Council assessment of clause 4.6 request

The applicant has lodged a Clause 4.6 variation request to vary the 12 m height control under Clause 4.3 of the State Environmental Planning Policy (Sydney Region Growth Centres) 2006. A copy of the applicant's Clause 4.6 submission is at attachment 7.

The areas coloured in white above the red 12 m height plane in the image below exceed the maximum building height permitted under State Environmental Planning Policy (Sydney Region Growth Centres) 2006 (for clearer reference, please refer to A107 Revision 2 dated 27 August 2021 at attachment 5).

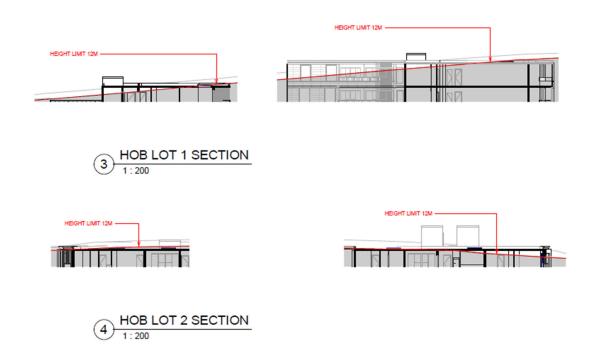
The proposed non-compliance relates to roof slab, lift overruns, with some breaches to the portions of units on Lot 1 on Buildings A1 and A2. For Lot 2, the breach relates to uppermost portion of the units, roof slab, the communal open space structures and lift overruns of Buildings B1 and B2. These exceed the height by up to 2.4 m or 20% for proposed Lot 1 and 3.1 m or 25.8% for proposed Lot 2. Consequently, the proposed building height is 14.4 m for proposed Lot 1 and 15.1 m for proposed Lot 2 at the highest point (lift overruns). The habitable area over the height limit of Lot 1 is 1,188 m² or 13.7% of the top floors of buildings A1 and A2 and for Lot 2 it is 174 m² or 2% of the top floor buildings B1 and B2.

- A strict compliance to the proposed building height variation is unreasonable in the circumstances for
 just plant, equipment and roof top open space but not for habitable floor space breaches and so we
 will be conditioning the removal of any unit that encroach over the height plane.

3.6 Based on the above assessment, the Clause 4.6 variation request is considered reasonable for plant and equipment and roof top communal open space elements only but not for habitable spaces and so these units that encroach the 12 m height plane will have to be deleted from the plans. On this basis only the development recommended for support.

The figures below show the habitable area over the height of building

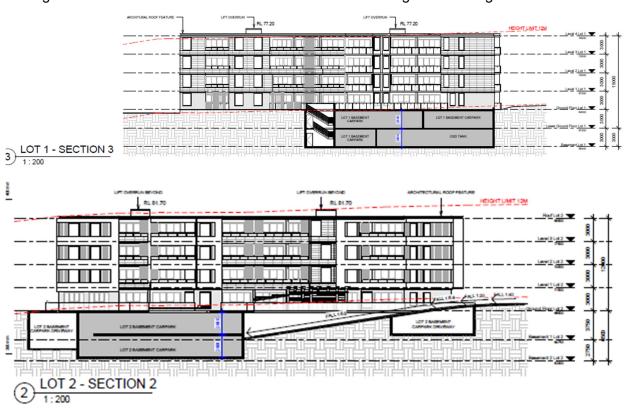
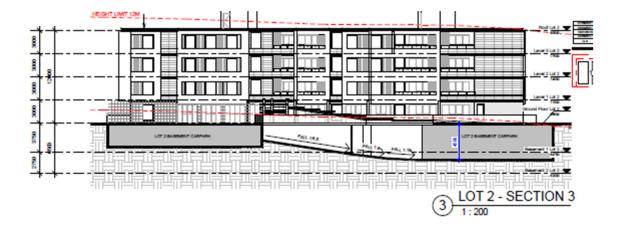
LOT 2 HABITABLE AREA OVER HOB 174 sqm

- By deleting the units above the height plane, the proposal in its amended form will not create
 additional overshadowing, privacy and streetscape impacts and therefore will present no adverse
 impact on its surroundings.
- The development when its amended, will still be in the public interest because it is consistent with the objectives of the development standard and the objectives for development of the zone.
- However, the applicant's written request justifying the contravention of the development standard has not adequately addressed the matters required to be demonstrated by Clause 4.6(3) to support any encroachment of the habitable floor space above the height plane. Only plant and equipment of roof top common open space features will be supported by this submission.
